# RENESAS TECHNICAL UPDATE

Product Category	MPU/MCU		Document No.	TN-RX*-A0238B/E	Rev.	2.00
Title	RX113 Group, RX130 Group Errata to User's Manual: Hardware Regarding the Realtime Clock (RTC)		Information Category	Technical Notification		
Applicable Product	RX113 Group, RX130 Group	Lot No.	Reference Document	RX113 Group User's Manual: Hardware Rev.1.20 (R01UH0448EJ0120) RX130 Group User's Manual: Hardware Rev.3.00 (R01UH0560EJ0300)		
		All

This document describes corrections to the "Realtime Clock (RTC)" chapter in User's Manual: Hardware for the applicable products.

Figure 24.3 Clock and Count Mode Setting Procedure

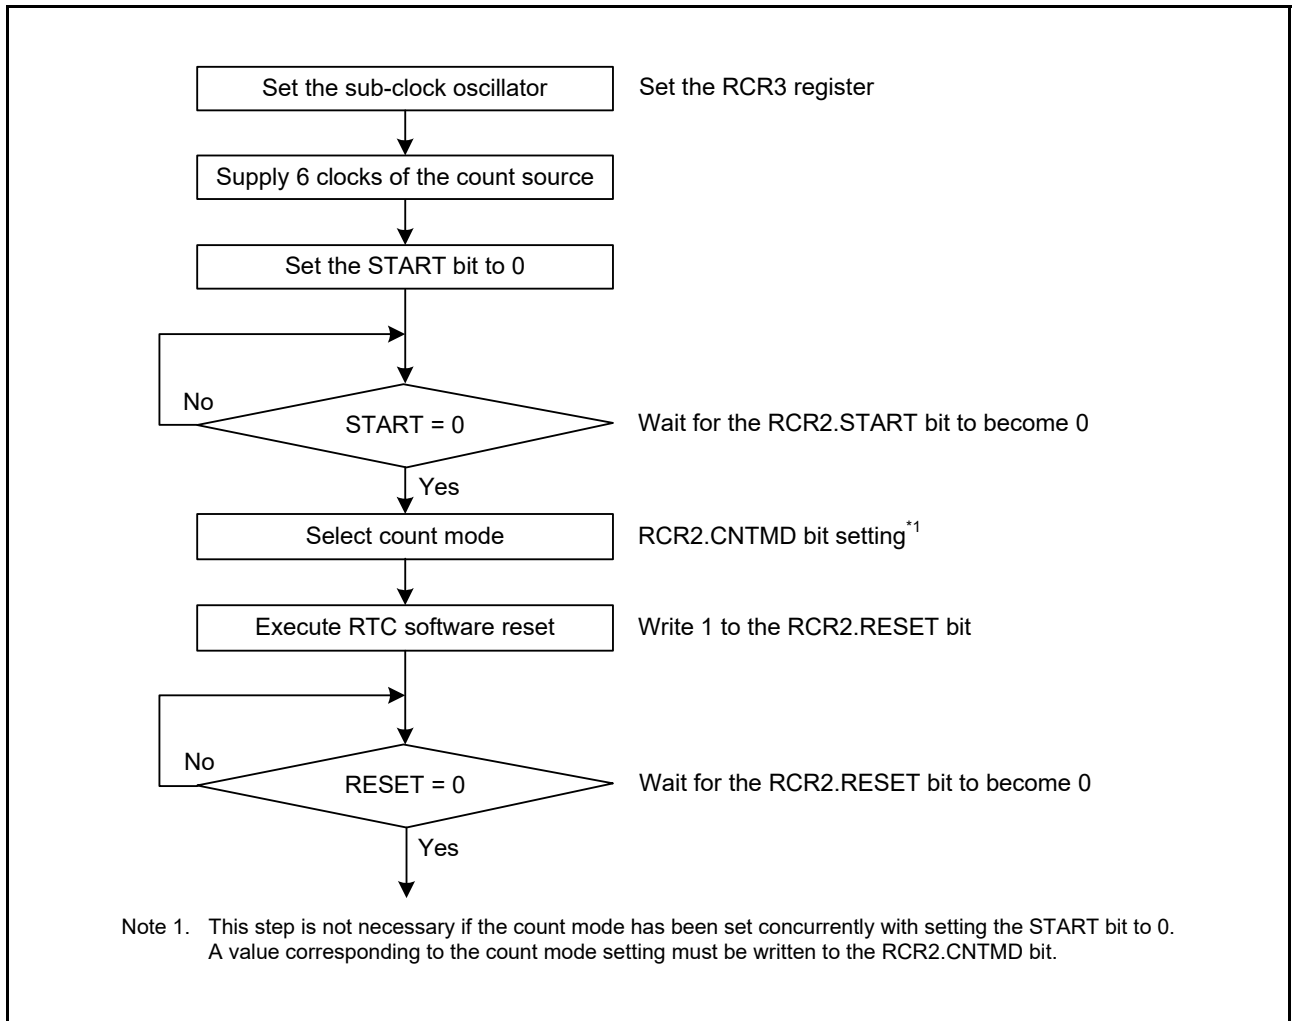
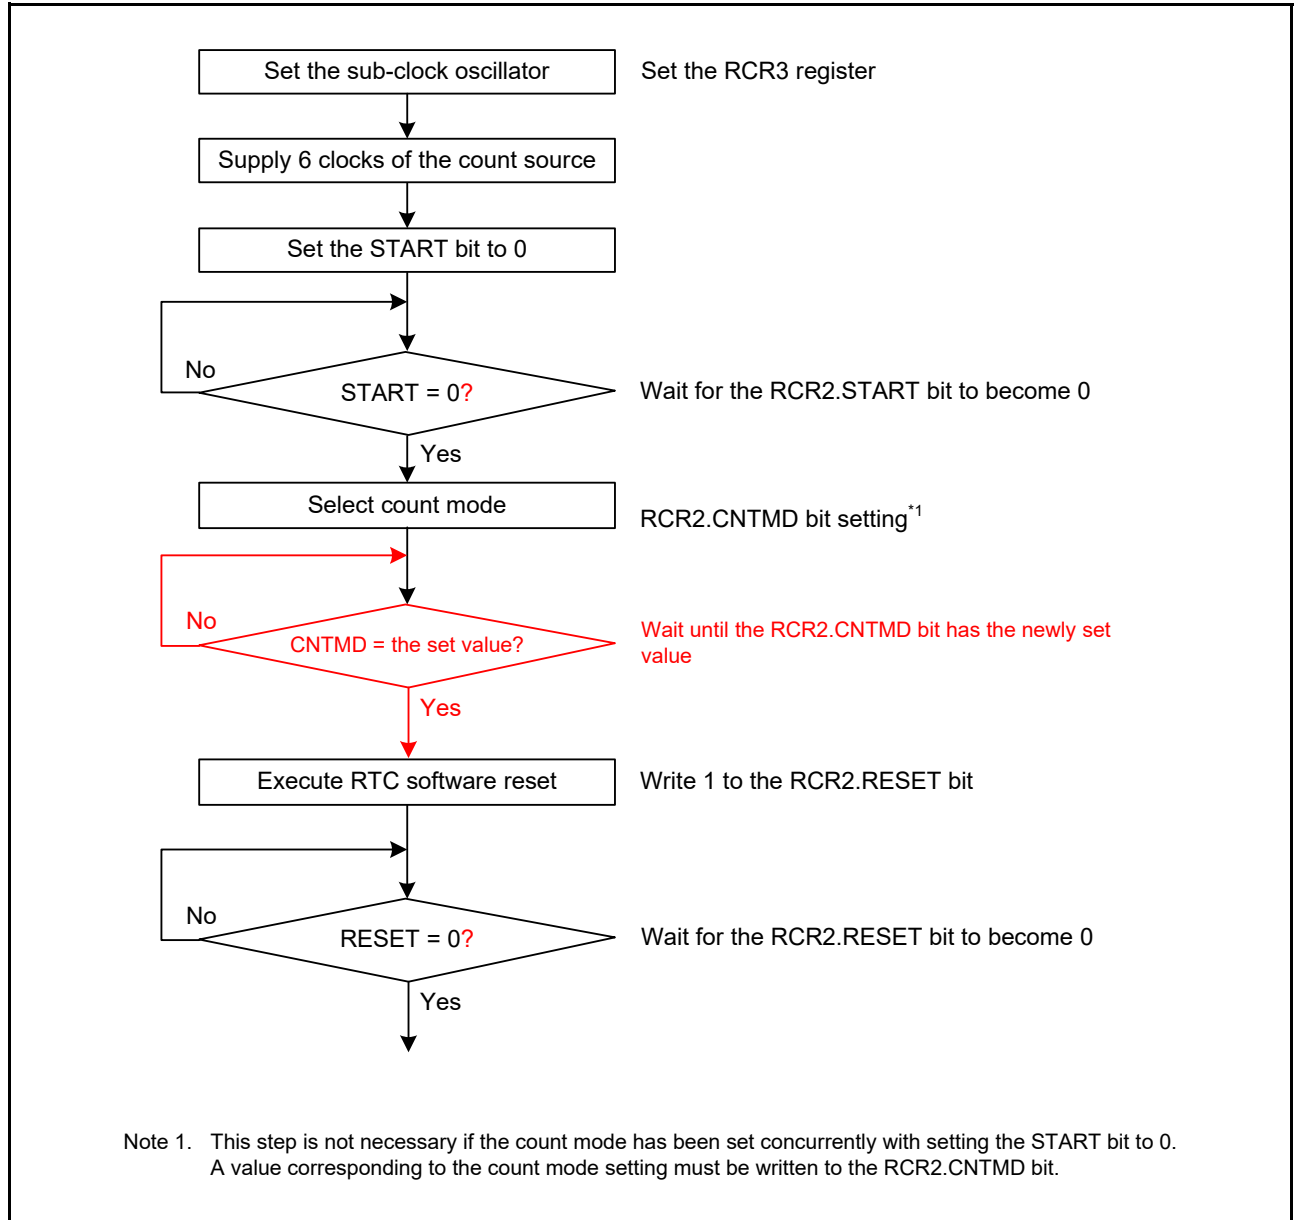
The setting procedure described in Figure 24.3, Clock and Count Mode Setting Procedure is corrected as follows.

Figure 24.12 Initialization Procedure

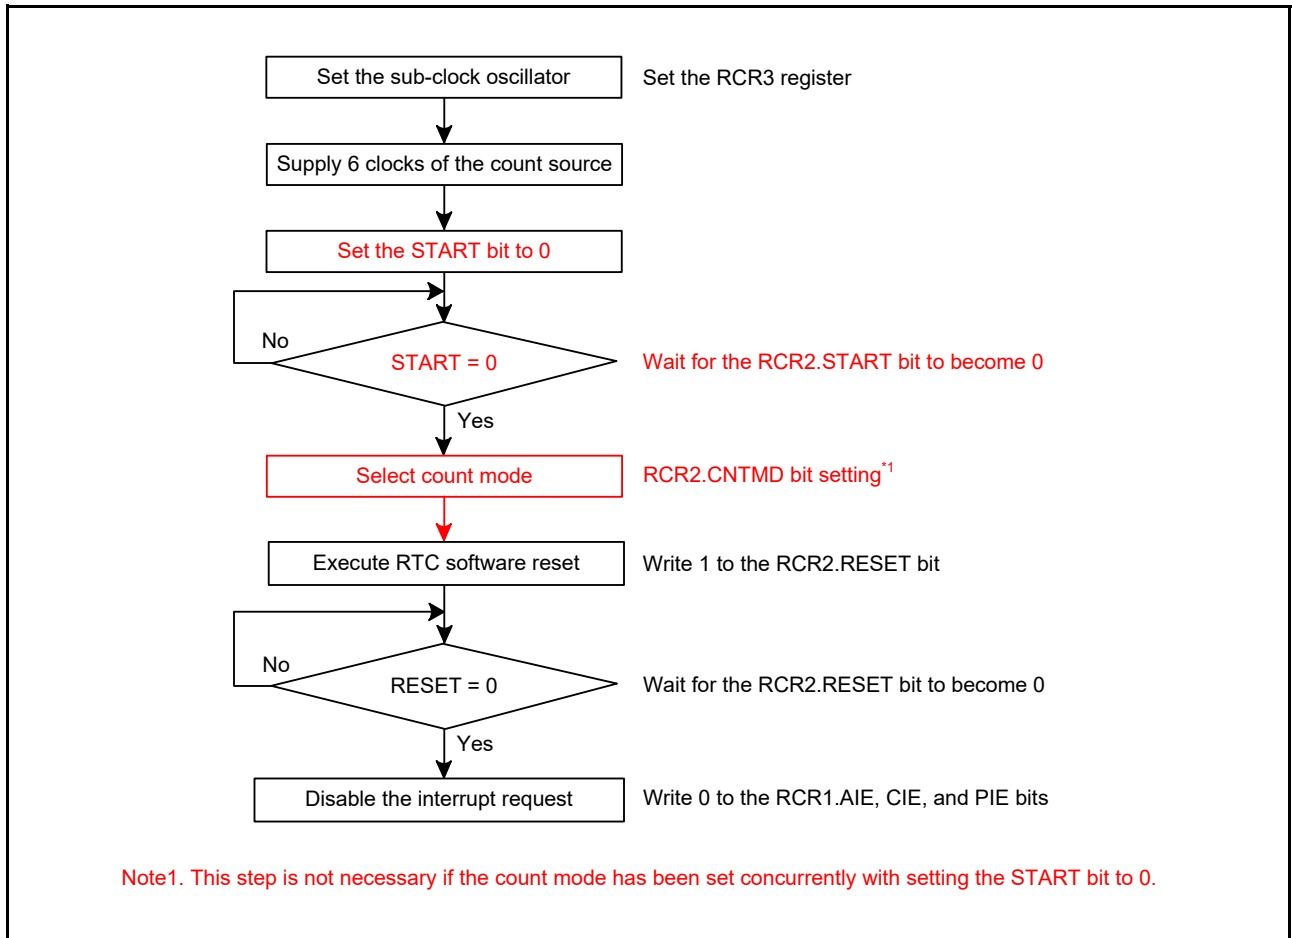
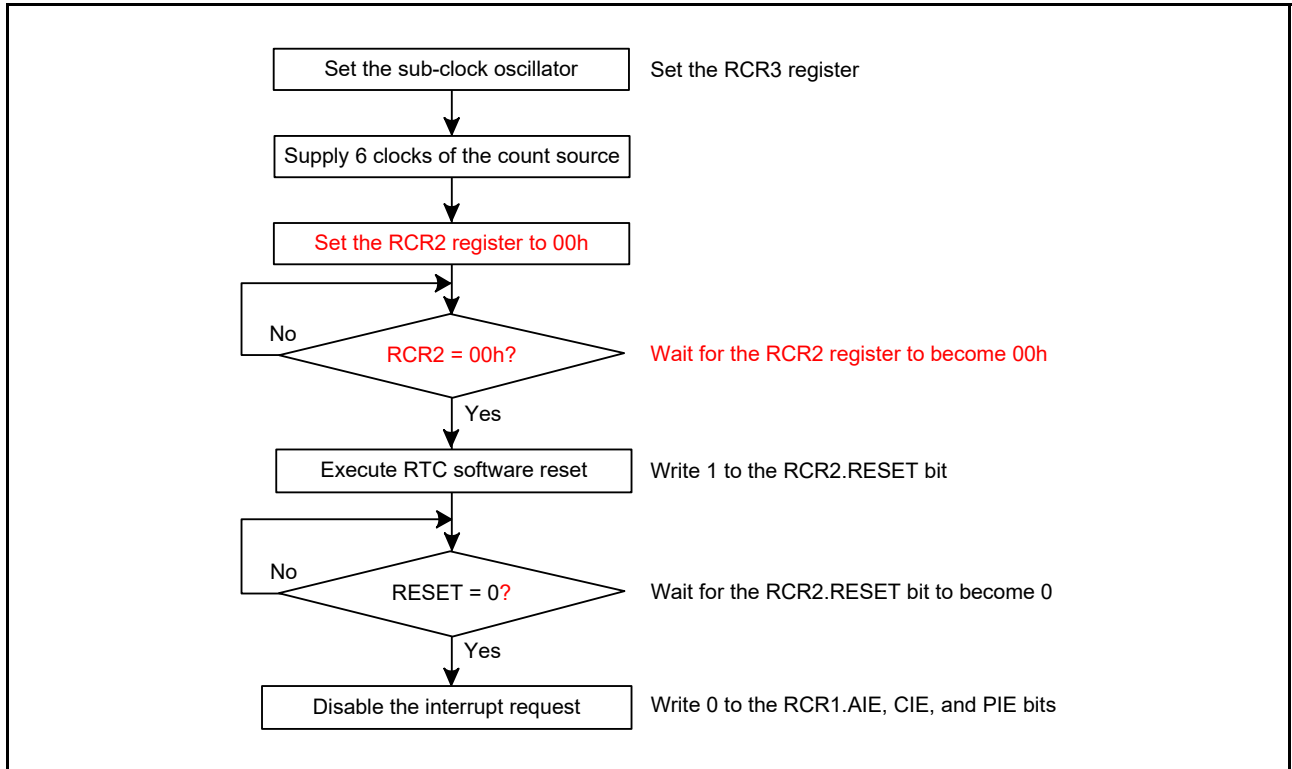
The initialization procedure described in Figure 24.12 of section 24.5.7 Initialization Procedure When the Realtime Clock is Not to be Used is corrected as follows.
